I am here tonight because I am concerned for the safety of the Stoughton area pilots who have airplanes at and use Matson airport. The concern is due to a tower being placed right on the centerline of our takeoff and landing pattern that is within 1 mile and 199' tall.

From: [mark.matson](#)
To: [Allan, Majid](#)
Subject: Proposed Tower Near Matson Airport (2WI6)
Date: Wednesday, March 1, 2023 9:17:28 PM
Attachments: [image.png](#)
[image.png](#)
[image.png](#)

Figure 1. PAPI light system: (a) the typical configuration of the PAPI lights; (b) a sample image of pilot's view.

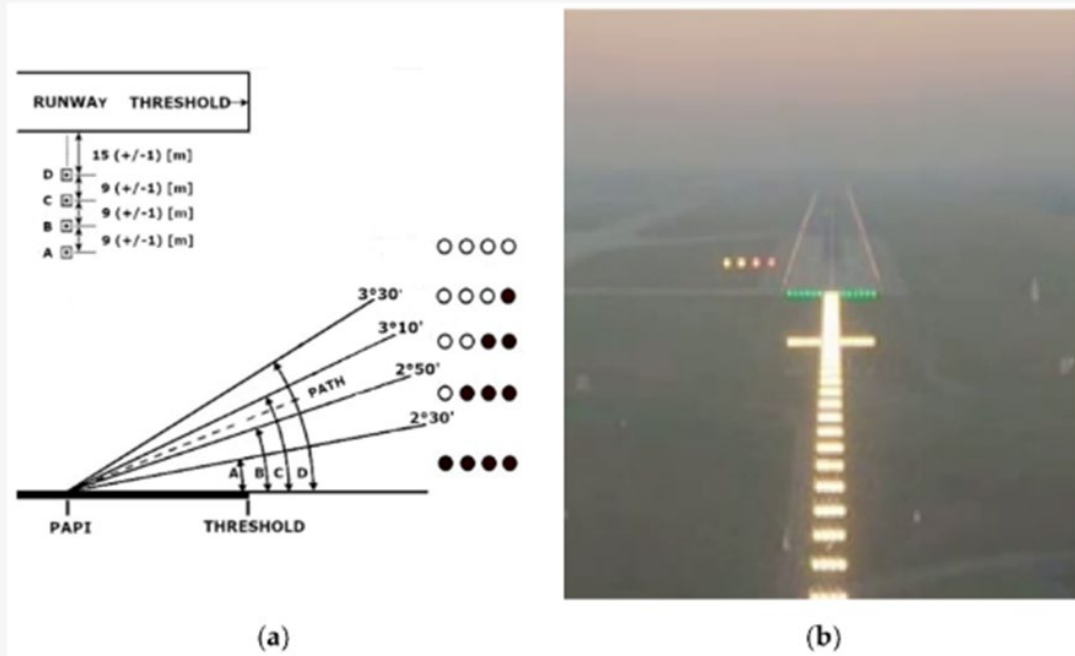
The previously supplied pictorial for a typical visually aided system is currently installed with the exact angles (2.5° to 3.5°, and glide slope of 3.0°), at the following nearby airports: Madison (MSN), Fort Atkinson (61C), and Watertown (RYV). Pilots are cautioned that VASI angles in excess of 3.5° may cause an increase in runway length required for landing and rollout.
https://www.faa.gov/air_traffic/publications/atpubs/aim_html/chap2_section_1.html

The visual aids were called out as a reference only. We do not have visual aids at Matson airport, and are likely not flying a glide slope as consistently or accurately as airports that do have them.

Proposed Tower Location

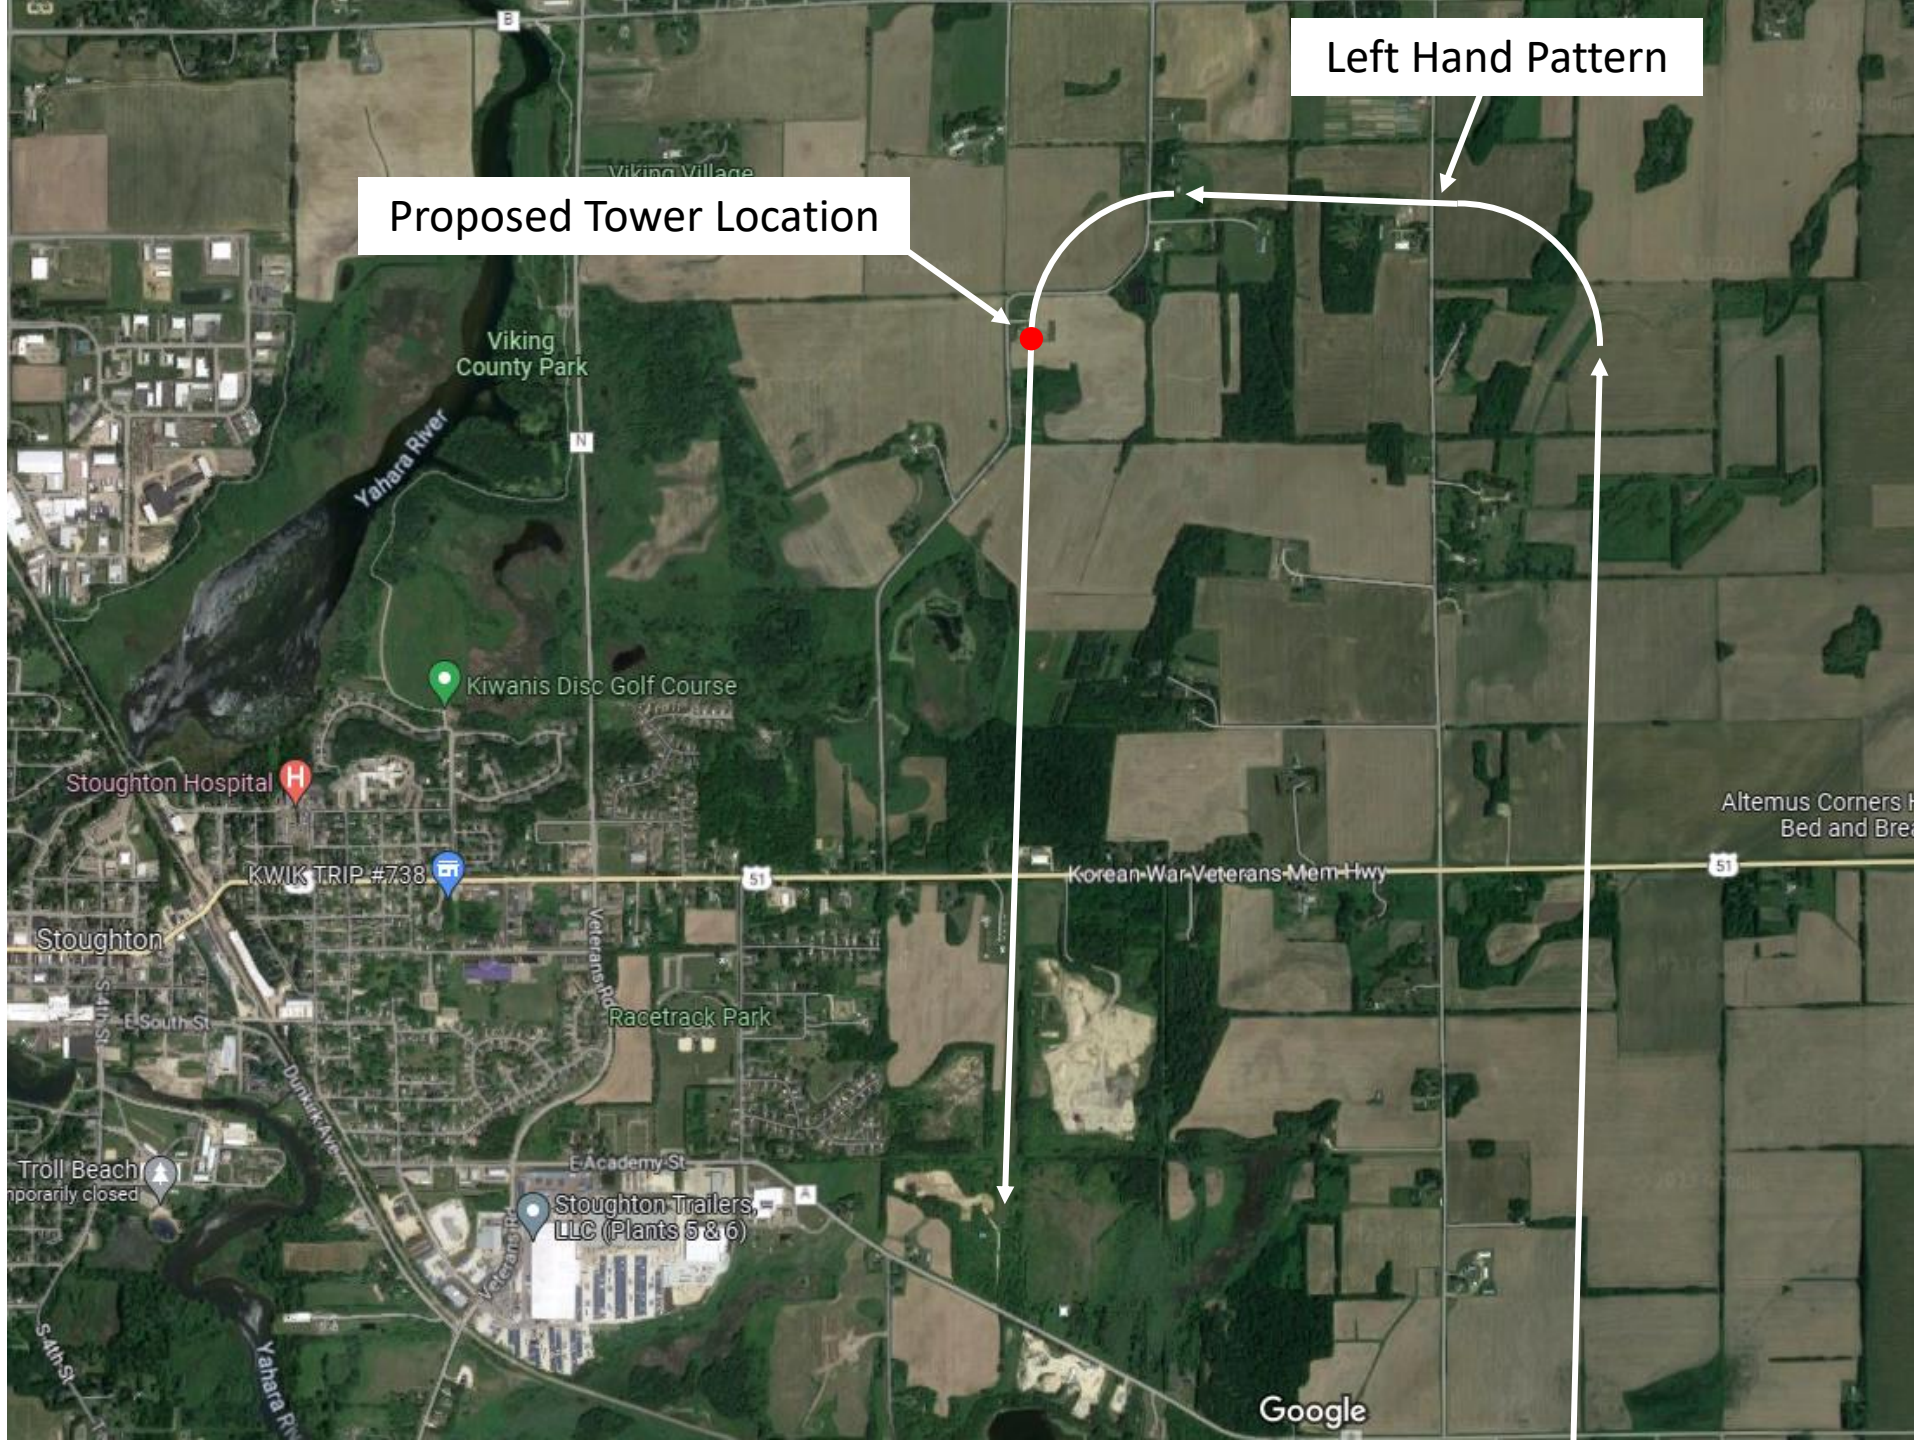
My personal recommendation would be to keep towers out of the red zones shown in the pictorial below. Given a 40 to 1 slope, a 199ft tower would need to be approximately 1.5 miles away from either end of a runway. This is consistent with Wisconsin Statute §114.135(7), and is more lenient than the FAA rules which callout a slope of 50 to 1 placing a 199ft tower approximately 1.9 miles away.

Straight In Pattern

5,100 ft
(measured on Google maps)

Left Hand Pattern
